Final Mitigation Plan Six Runs Stream and Wetland Mitigation Project

DMS #: 100170 | Contract #: 0303-01 | RFP: 16-20190303
USACE Action ID: SAW-2020-01964 | DWR #: 20201798 v1
Cape Fear River Basin | HUC 03030006 | Sampson County, North Carolina

SUBJECT: NCDMS Six Runs Mitigation Project - NCIRT Comments during 30-day Mitigation Plan Review, Sampson County, NC

RE: Response to Final Draft Mitigation Plan Comments – Six Runs Mitigation Project (DMS #100170) Cape Fear 03030006; Sampson County, NC; Contract No. 0303-01

SHEET NUMBER:
S2

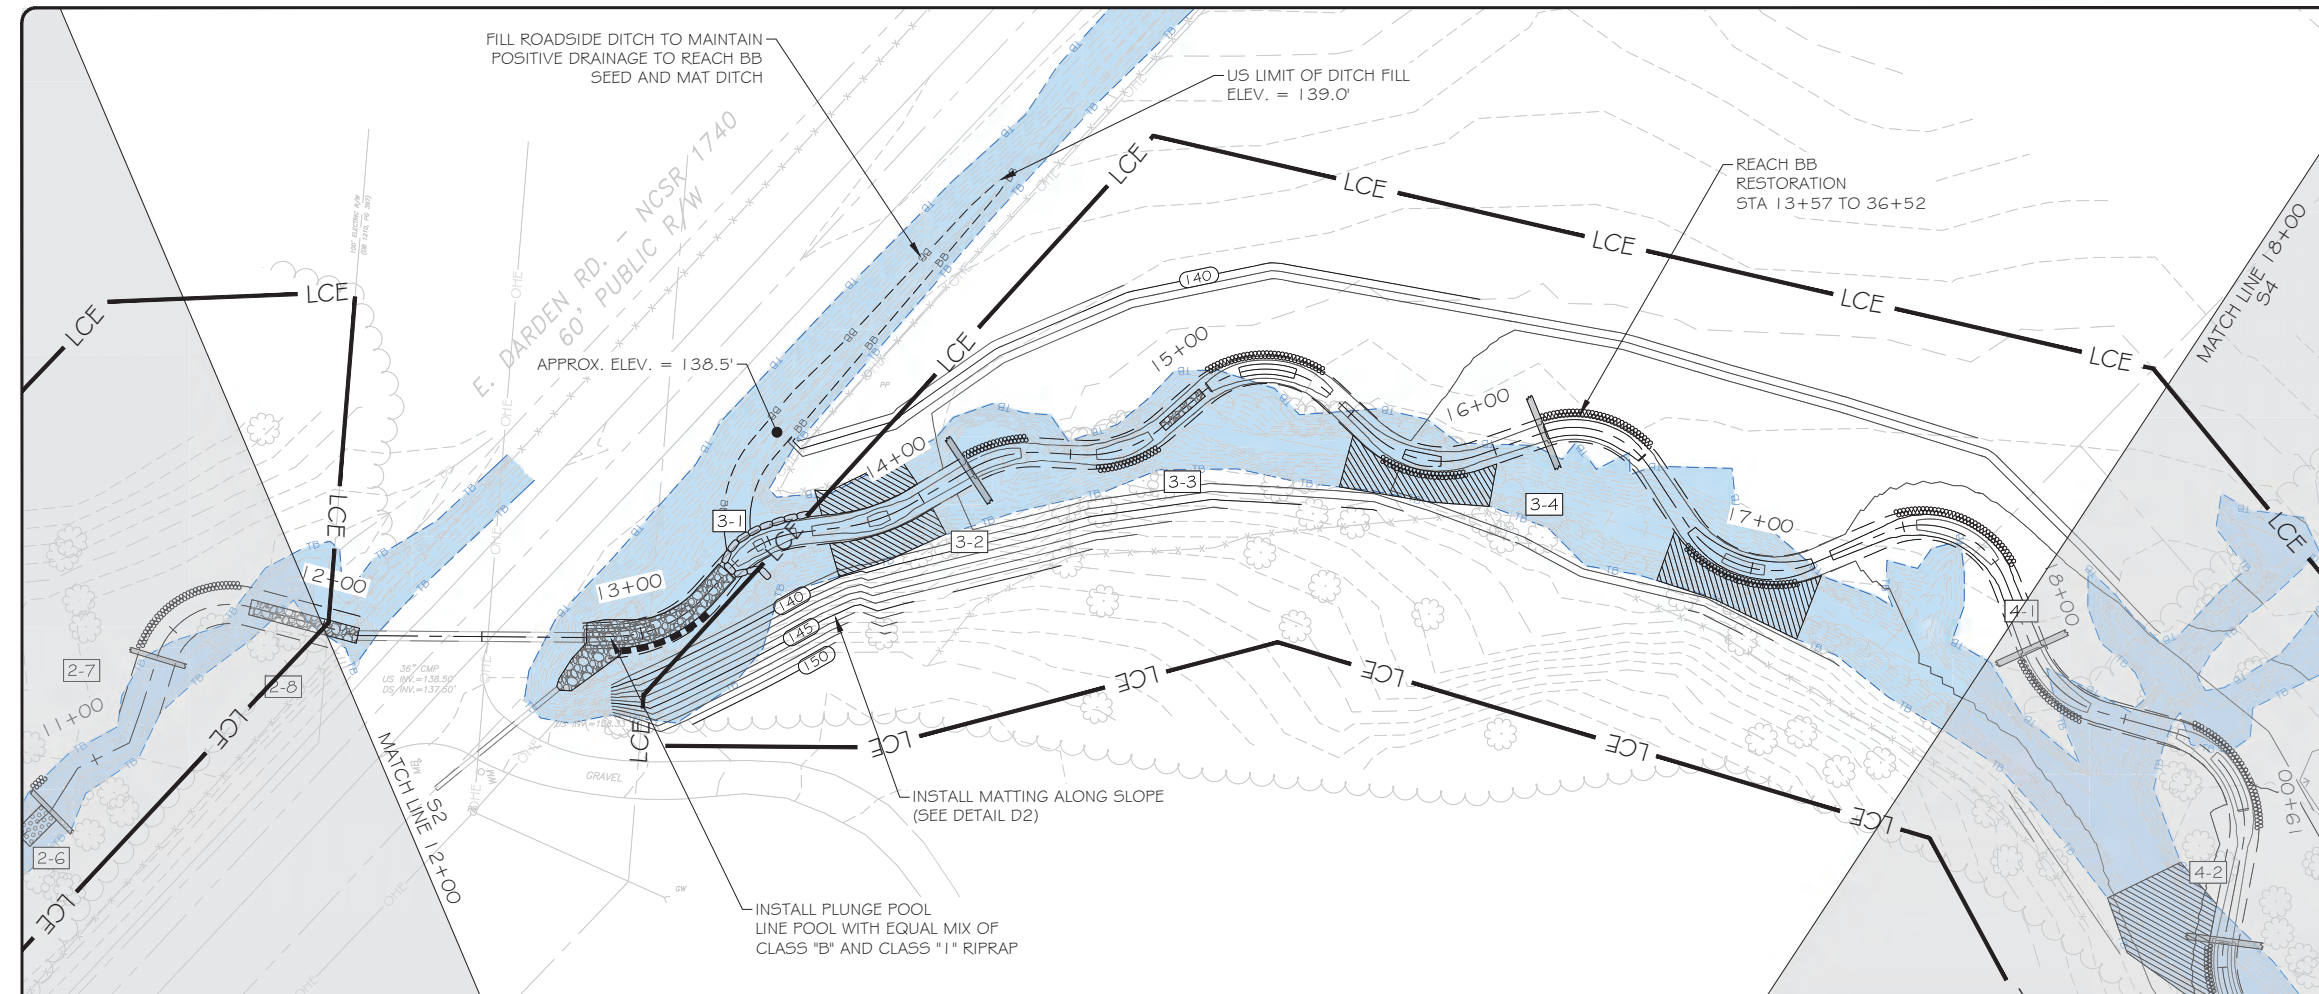
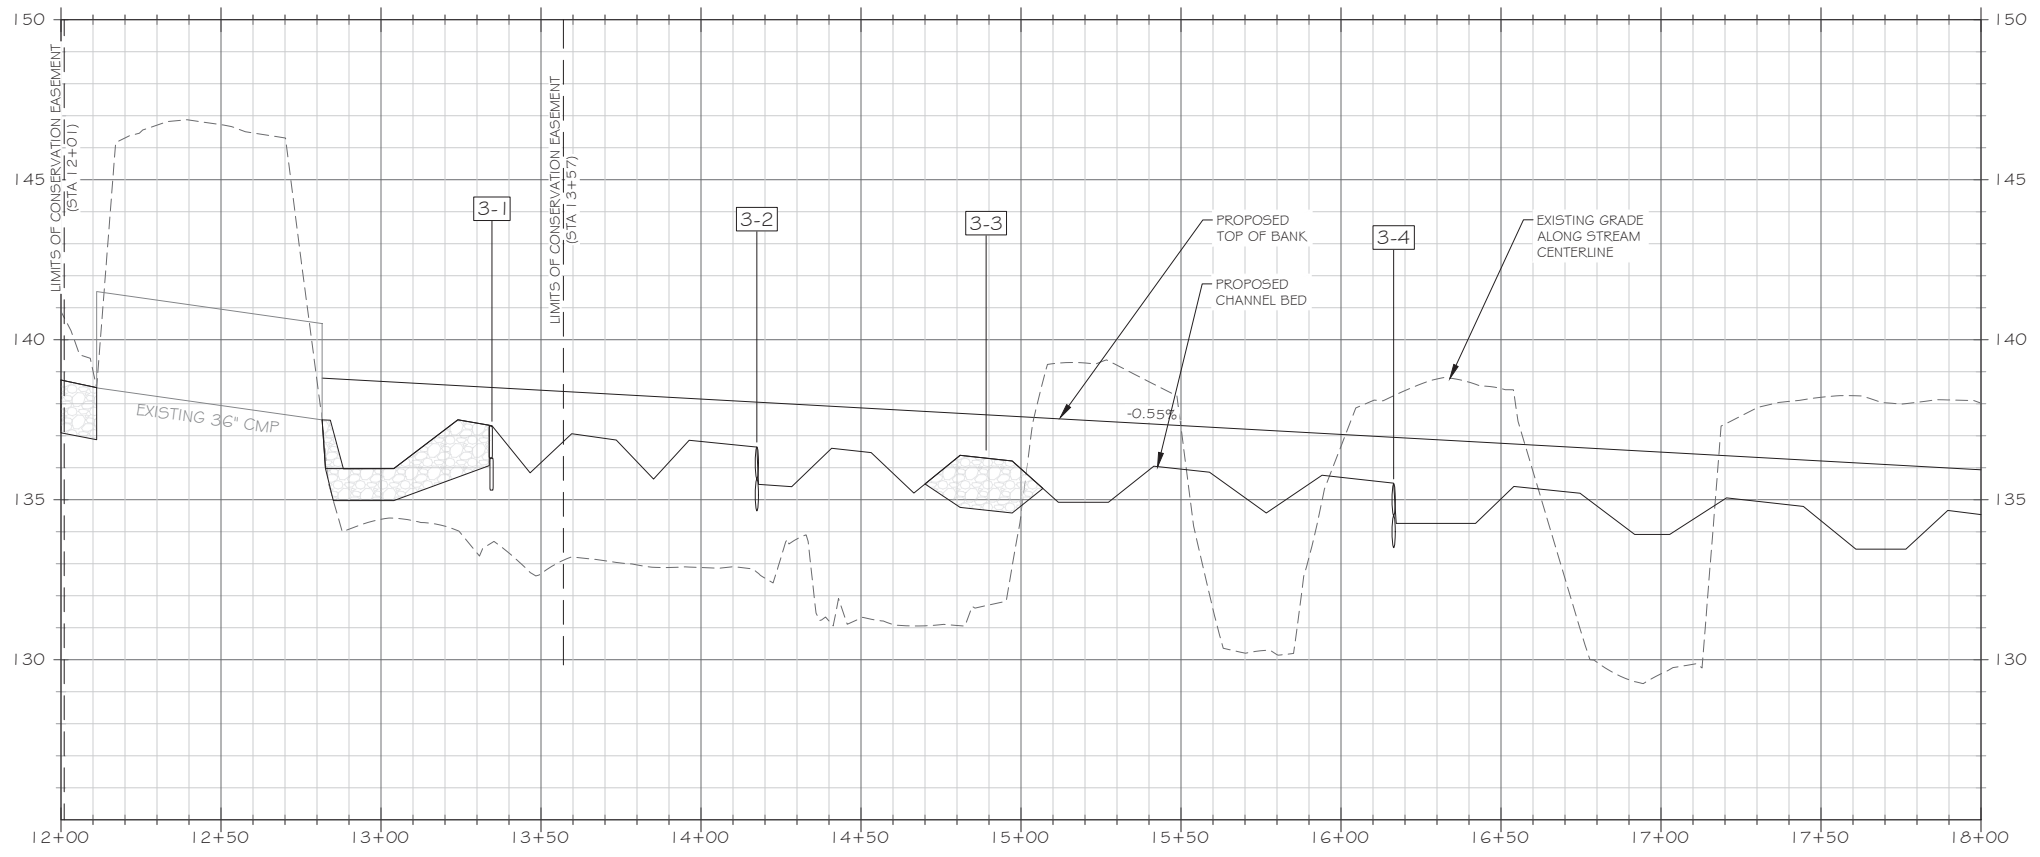
20. Sheet S2 – DWR understands that there is a required easement break for the existing overhead electric line and buried water line. Since no bed or bank stabilization is proposed, please confirm that this break is not intended to be used as a livestock or vehicle crossing and that cattle will not have access to the stream.

20. Sheet S2 – DWR understands that there is a required easement break for the existing overhead electric line and buried water line. Since no bed or bank stabilization is proposed, please confirm that this break is not intended to be used as a livestock or vehicle crossing and that cattle will not have access to the stream.

The fenceline has been updated to extend across the easement break. This is not a crossing nor will cattle have access. The plan sheets and **Figures 10 & 12** have been revised accordingly.
